## **ADDENDUM 1 – BID PACKAGE 2 PHASE B, C, D**

**DATE:** January 7, 2022 **M2 PROJECT #:** 201001

**PROJECT:** Greater Peoria Mass Transit

**OWNER:** GPMTD/ Citylink  
2105 N E Jefferson Ave, Peoria, IL

COM-501

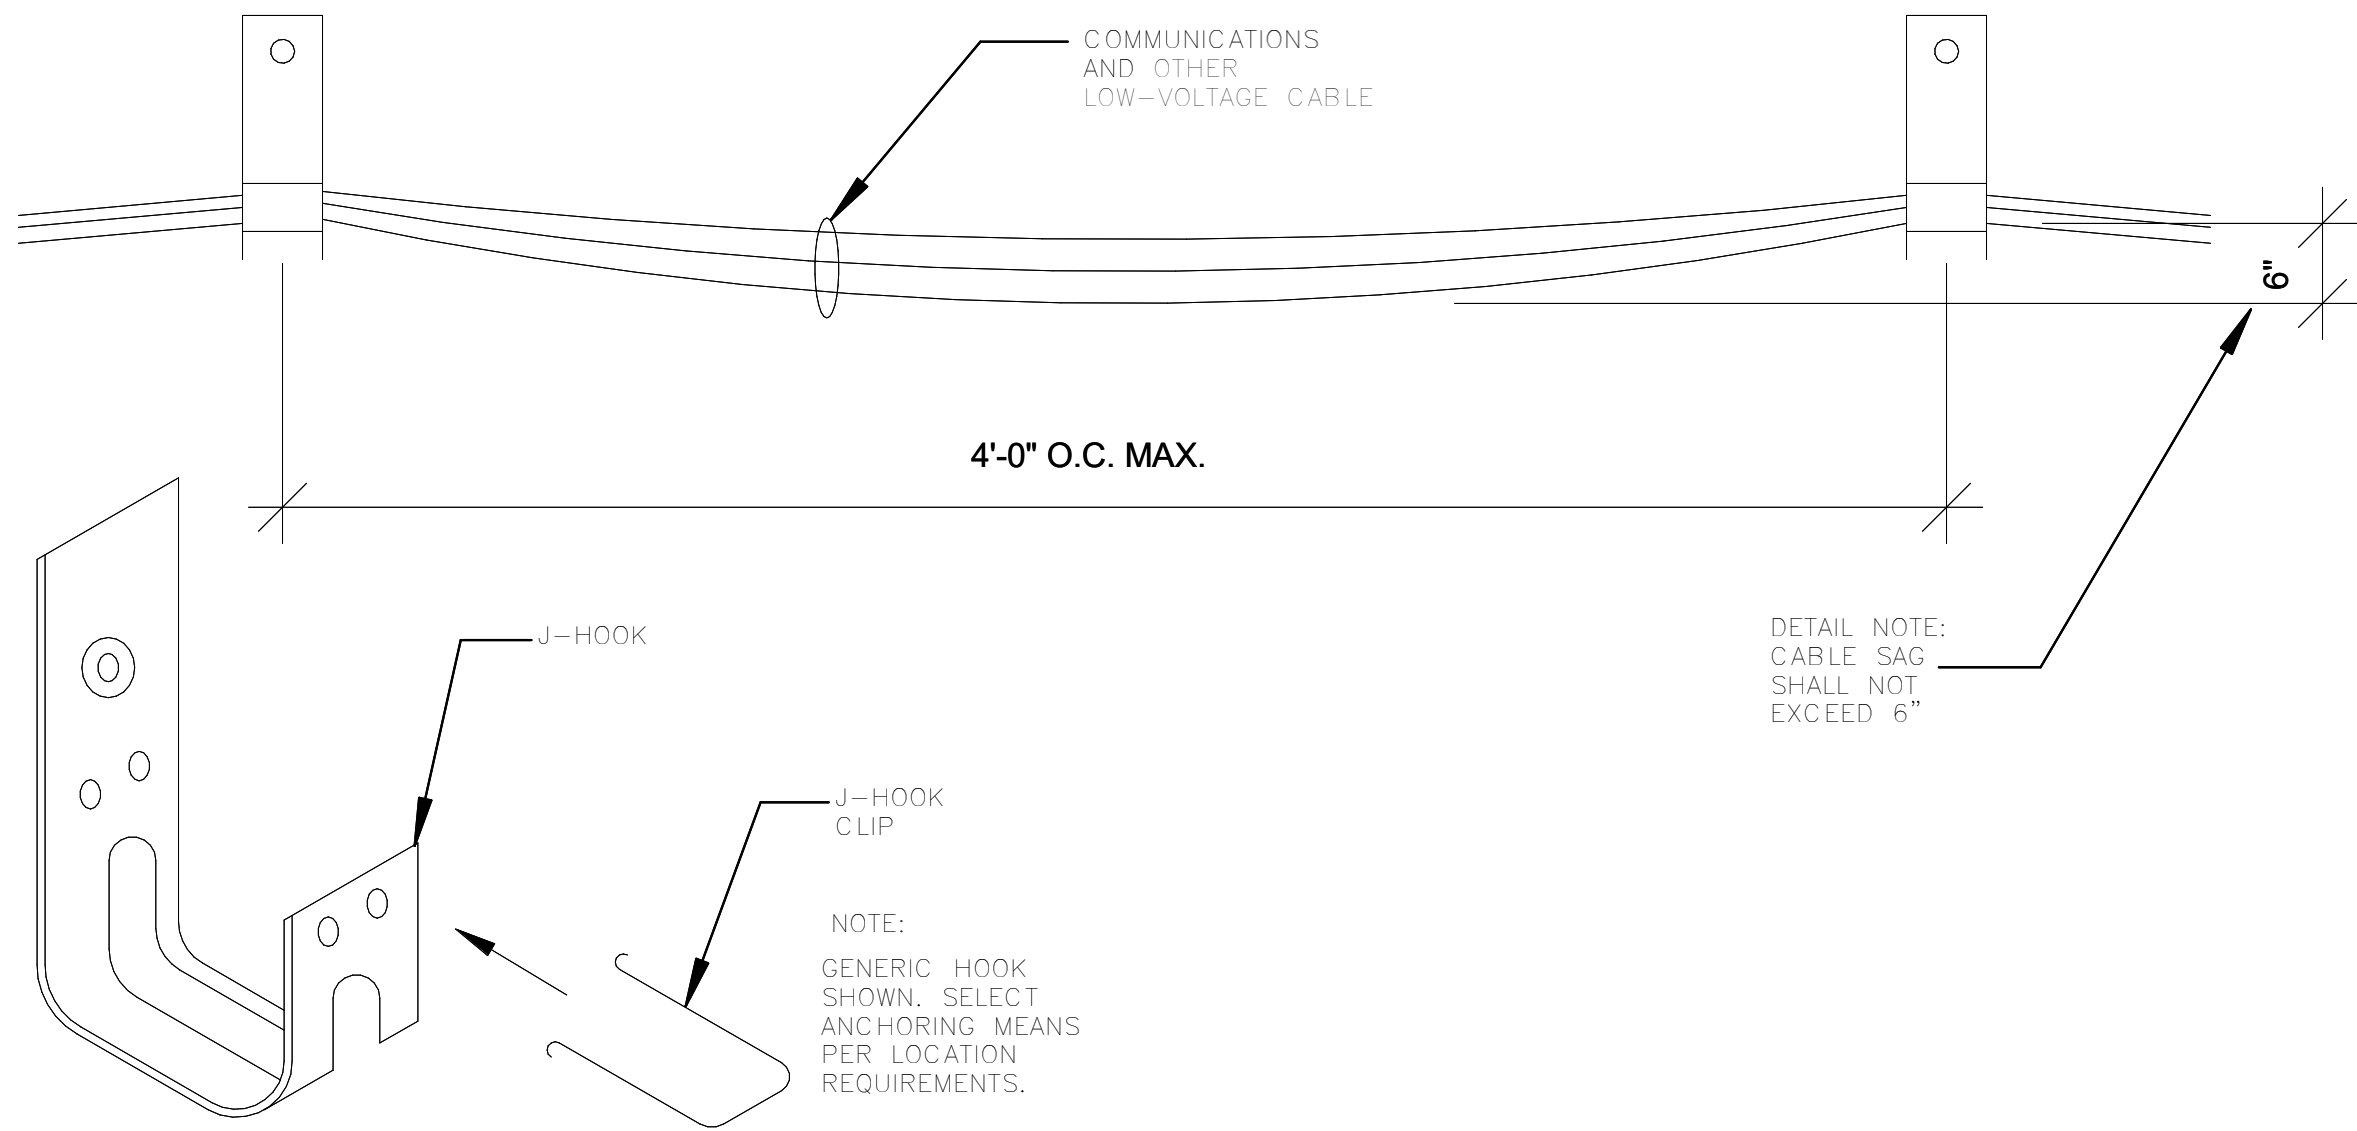
Updated camera schedule to reflect new parking lot camera specifications.

## 6 TELECOMMUNICATIONS GROUNDING RISER DIAGRAM AND BUSBAR DETAIL

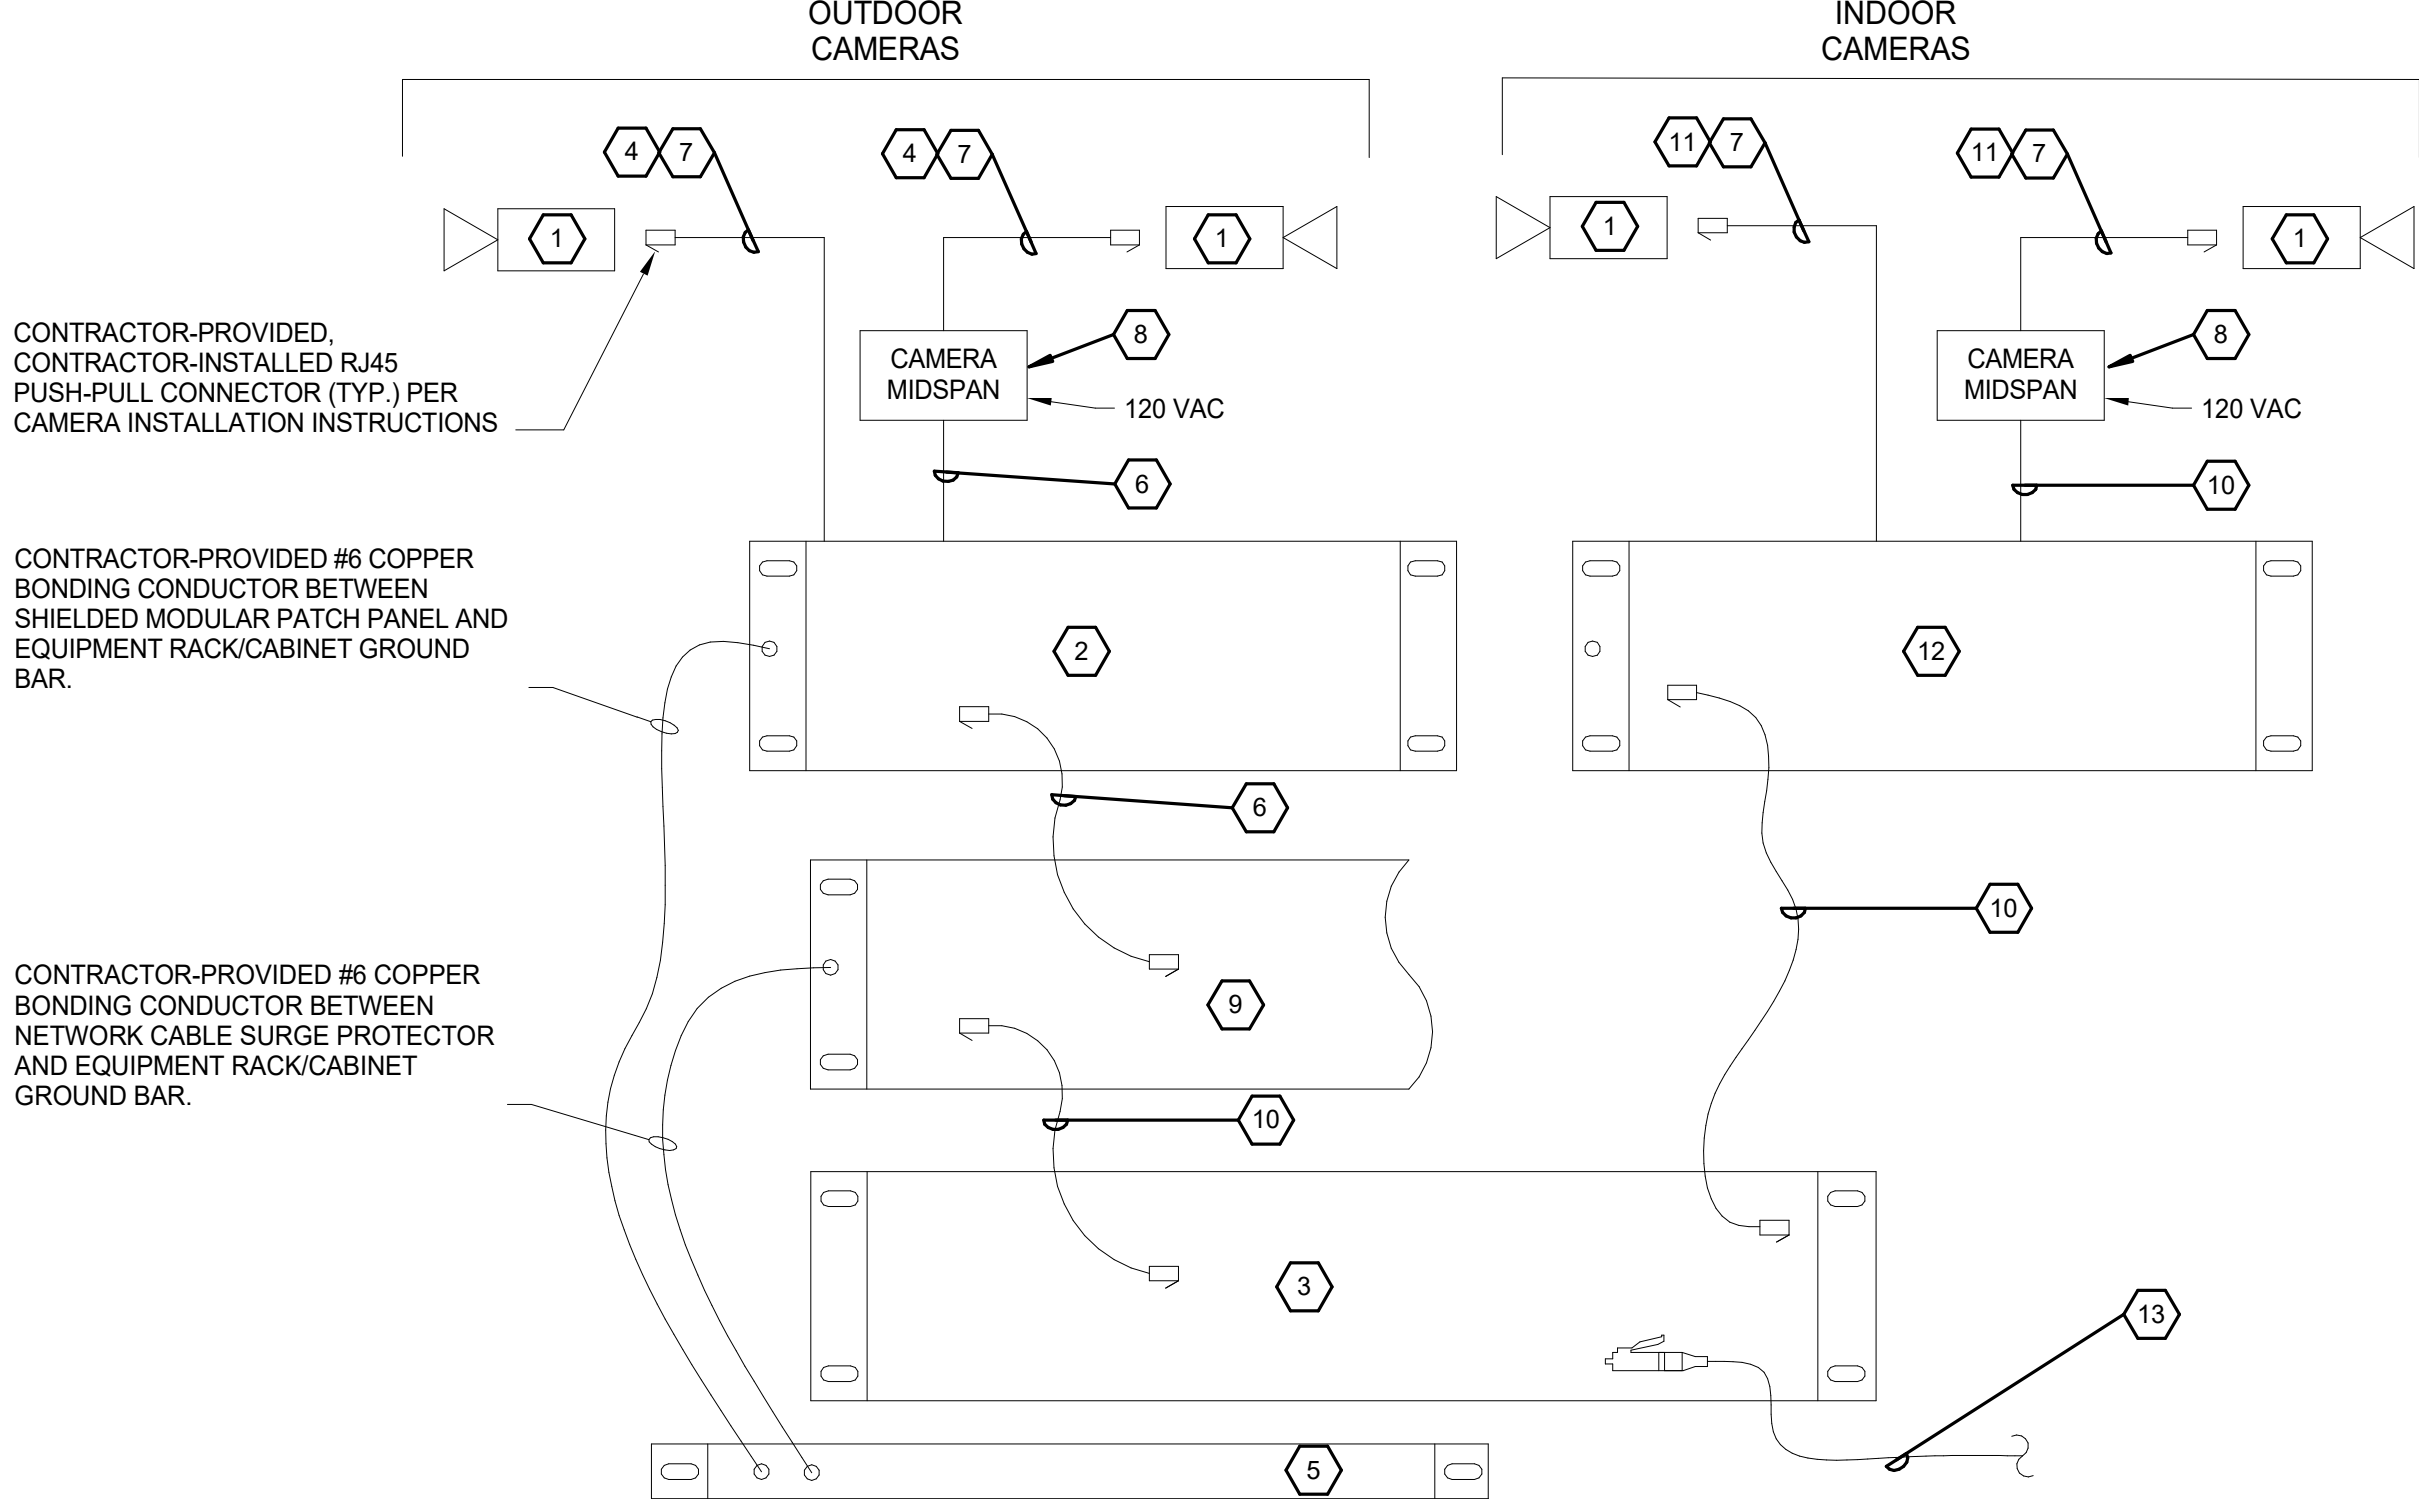
Updated detail 6 TELECOMMUNICATIONS GROUNDING RISER DIAGRAM AND BUSBAR DETAIL to reflect ground bus IDs.

7 CAMERA MOUNT DETAIL - POLE-MOUNTED CAMERA

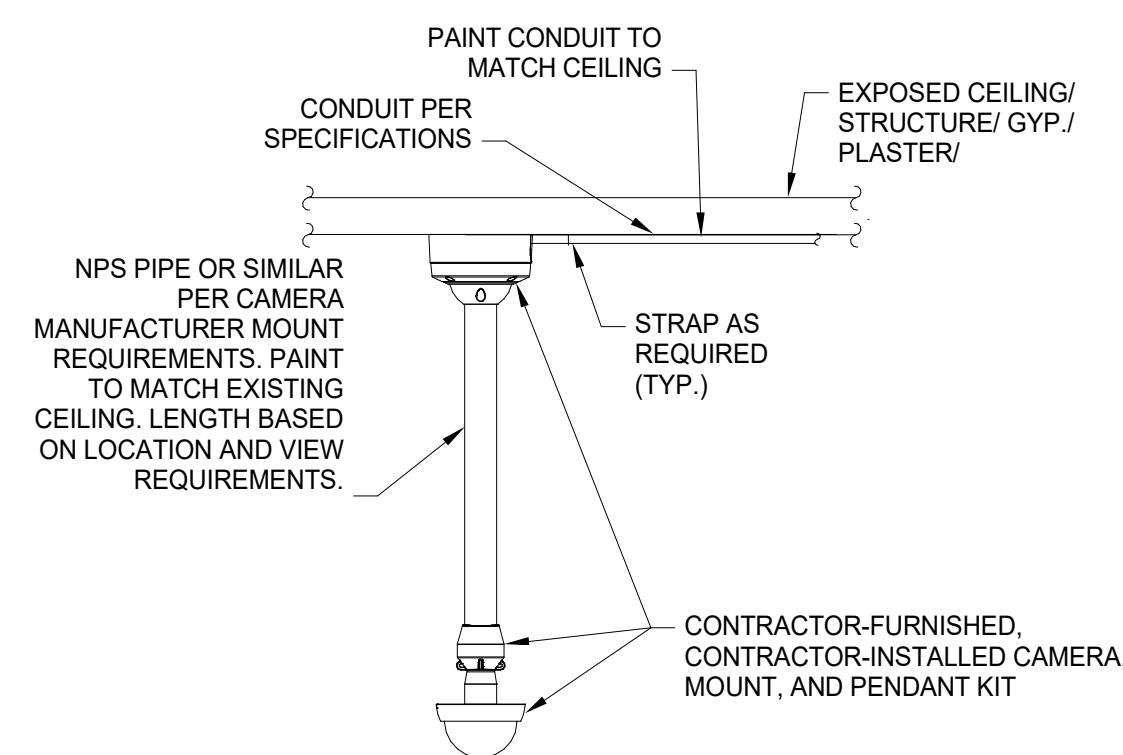
Updated detail 7 CAMERA MOUNT DETAIL – POLE-MOUNTED CAMERA to reflect cameras being installed onto light poles rather than on dedicated camera poles.

### EQUIPMENT OUTLET FOR WIRELESS ACCESS POINTS DETAIL

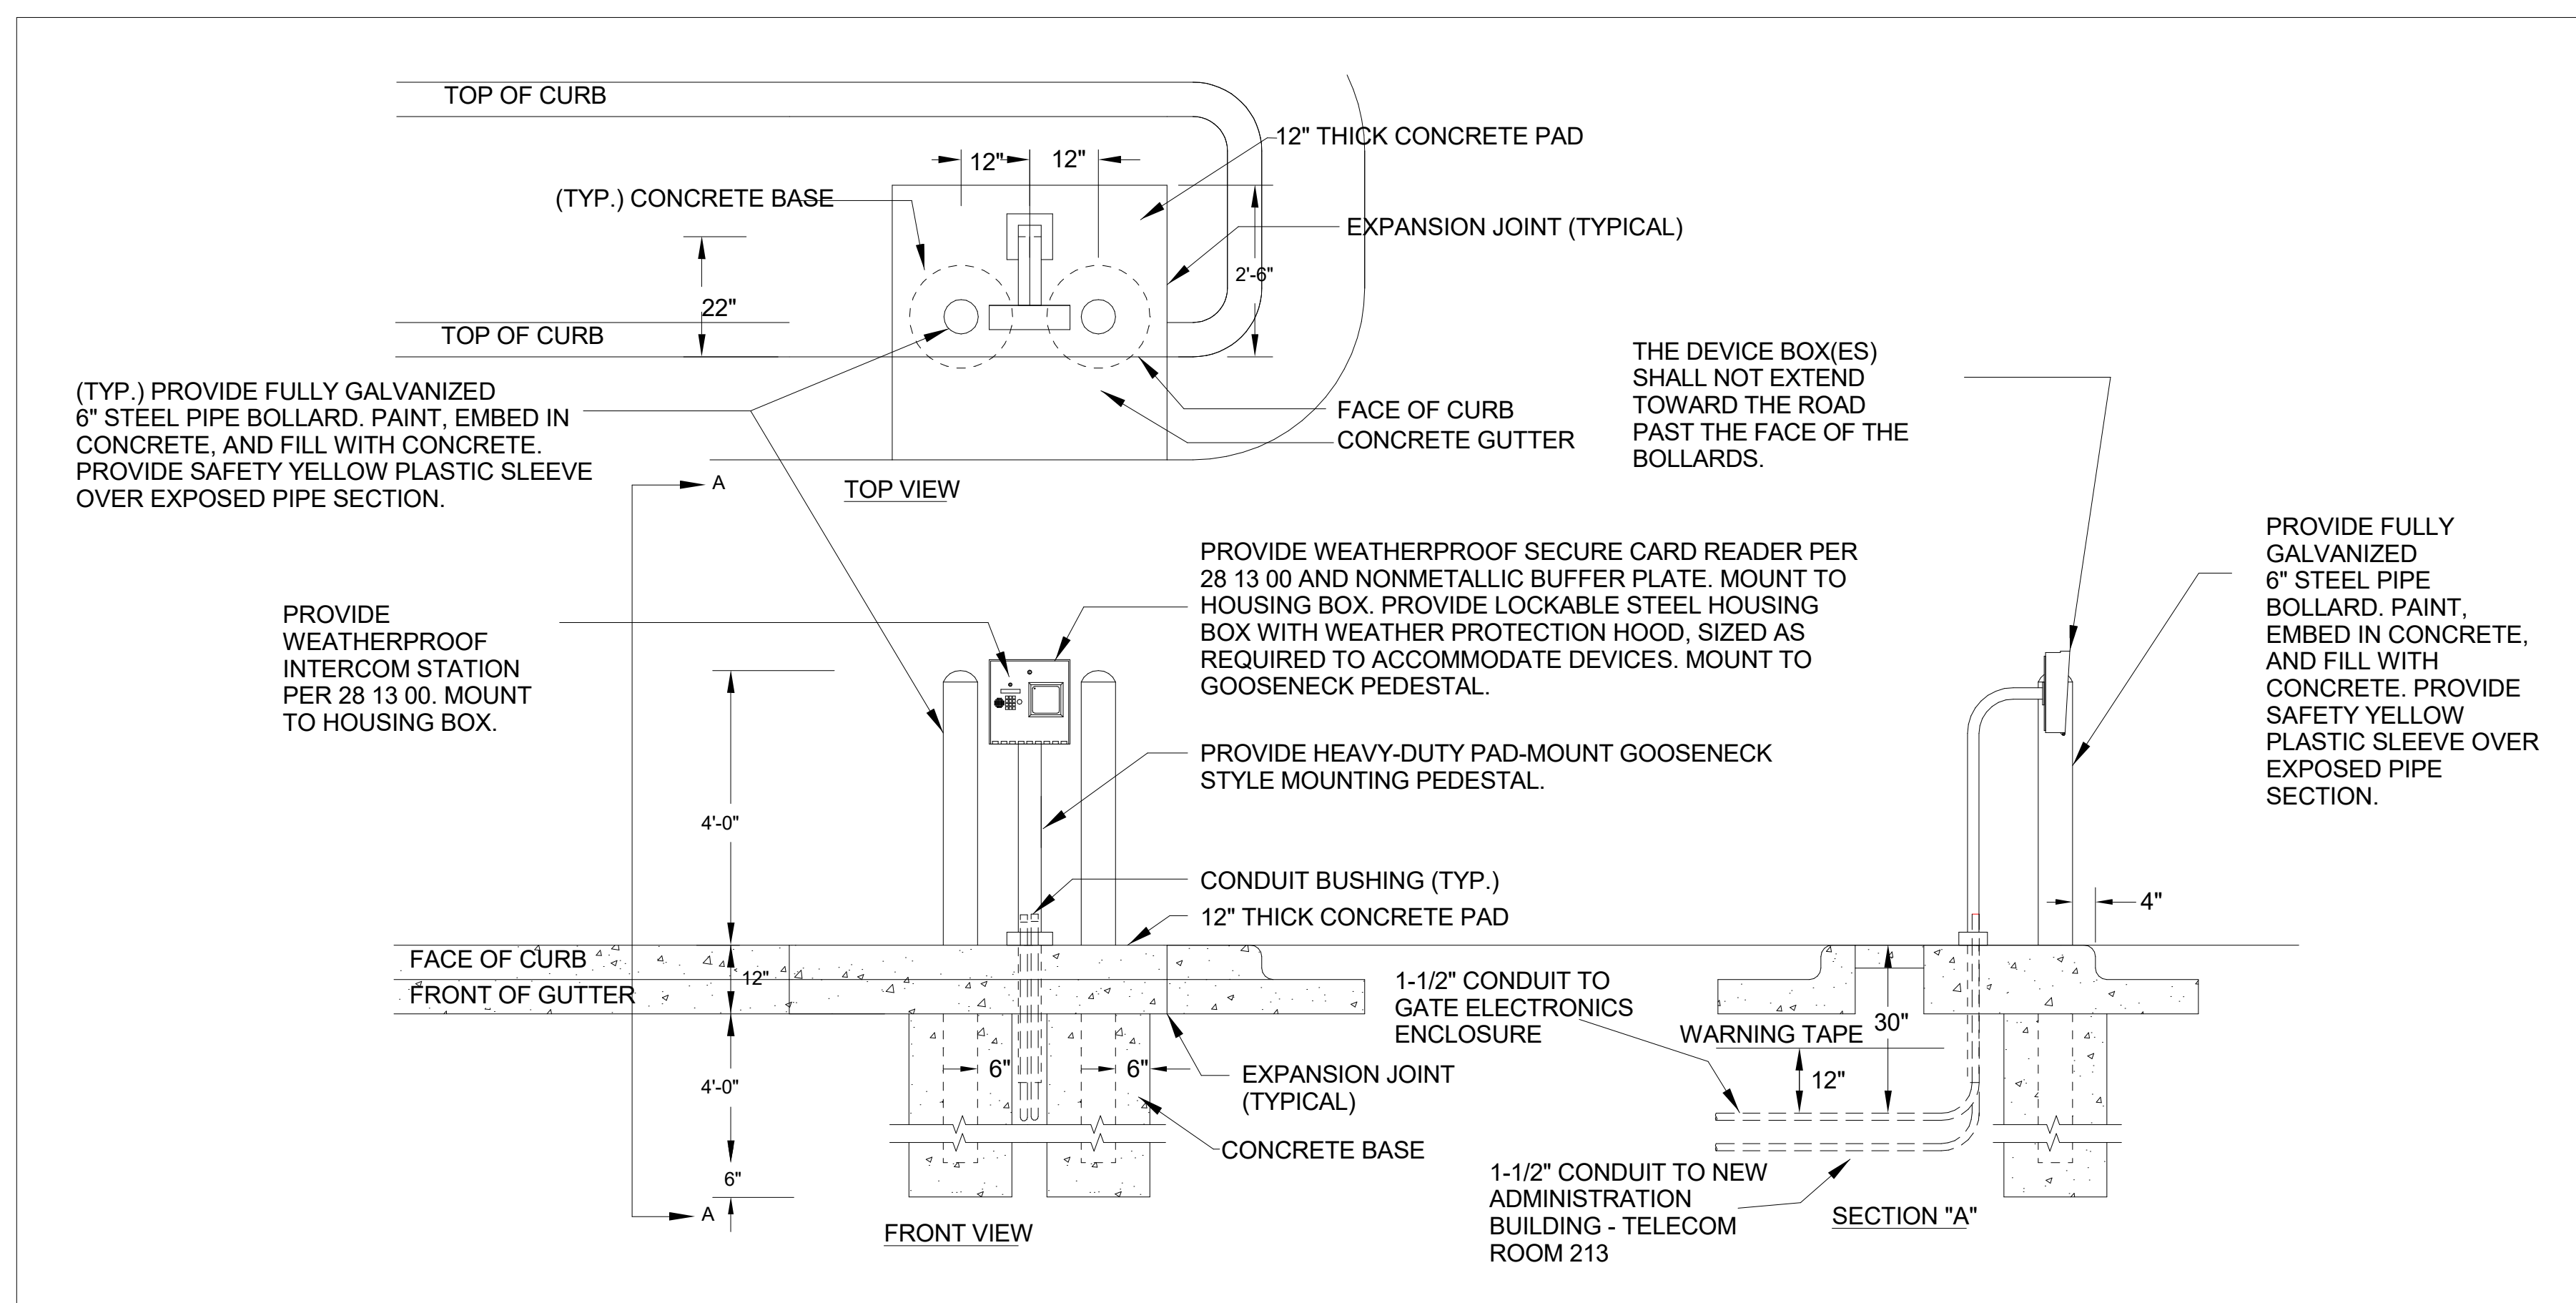
Updated detail 1 EQUIPMENT OUTLET FOR WIRELESS ACCESS POINTS DETAIL to reflect that contractor is furnishing and installing WAPs.
